Adopt the Staff Recommendation with Amendments to the Conceptual Design:

HOPKINS CORRIDOR

Concept to extend the 2-way protected cycle track from The Alameda to Sutter

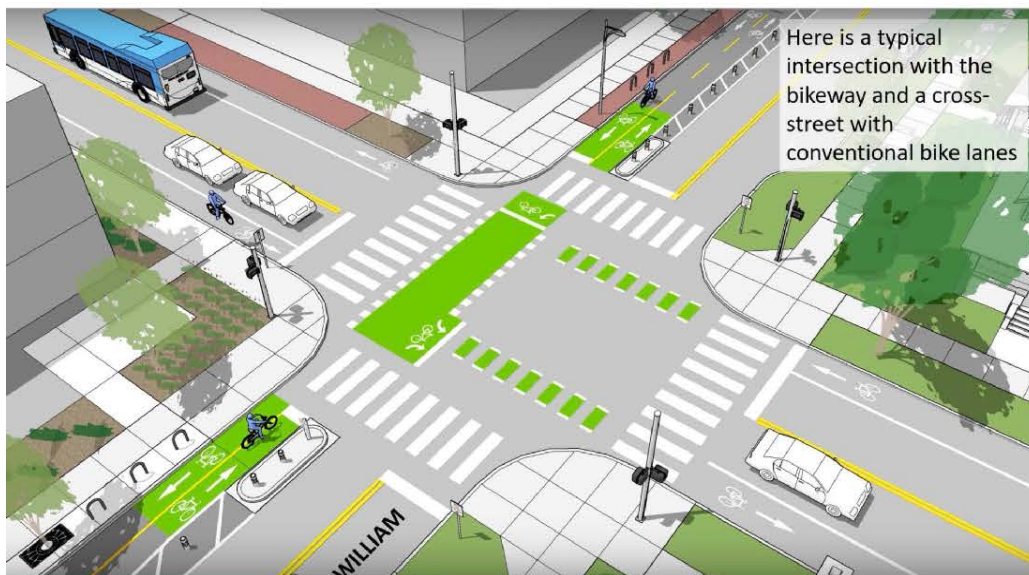
- **Replace the proposed design for Segment 1: Sutter to the Alameda (Pages 8, 9, and 10 of 20) with extension of two-way parking-protected bike lanes (cycletracks) along the entire south side of Hopkins and increase the width of parking buffers to provide approximately 10 foot islands composed of sidewalks with wheelchair access adjacent to vehicle parking and planting strips, as sketched below (TC):**
